Detroit
Edison

Subject: Enrico Fermi Atomic Power Plant, Unit 2,
Docket No. 50-341
Responses to NRC Environmental Review Questions

A.4 RESPONSES TO NRC ENVIRONMENTAL REVIEW QUESTIONS

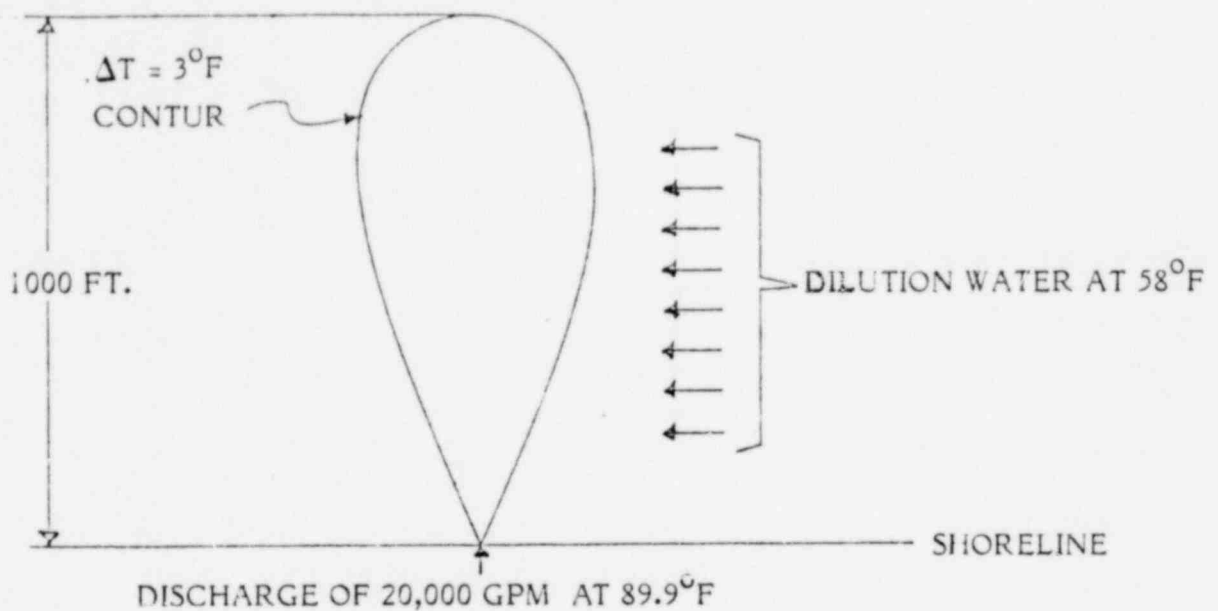
6. (Section 2.7.1.2 and Appendix A.2-Item 350.5) In the discussion on Eutrophic Impact in Subsection 5.1.2.2.6 it is stated that "the discharge water will be rapidly diluted and distributed in the lake." What is the basis for this statement? Since the bottom does not slope much and the water is shallow in the vicinity of the plant it would seem that the rates of water exchange between the water body adjacent to the plant and Lake Erie as a whole would be relatively slow. Can calculations be made which compare this exchange rate to the volume rate of discharge to the lake? Provide proper revised text for Item 250.5 (September 22, 1978).

From Table 1 it can be seen that the discharge concentration of either temperature or dissolved solids will be reduced to 50 percent within 200 feet of the discharge point and to 10 percent within 1000 feet of the discharge point. This rapid decrease in concentration of either temperature or dissolved solids justifies the statement. "The discharge water will be rapidly diluted and distributed in the lake."

The lake bottom at the discharge location slopes away from the shoreline at an approximate slope of 1:180. The water depth 1,000 feet offshore of the discharge point would be 7 feet. Referring to the sketch below which depicts Case 3, an extreme case; (i.e. large discharge and ΔT , lower than existing MWL of 572, and dilution from one side of the plume) the lateral velocity required to provide the required plume dilution water would be approximately 0.1 foot per second.

For a lake level of 575 feet, a discharge of 10,000 gpm, a ΔT of 31.9°F, and entrainment of dilution water from both sides of the plume (Case 5 in the Environmental Report) the required lateral velocity would be less than 0.02 fps to dilute the plume to a ΔT of 3°F. Typical values for the lateral velocity at the Fermi power plant site range between 0.4 and 1.0 fps.
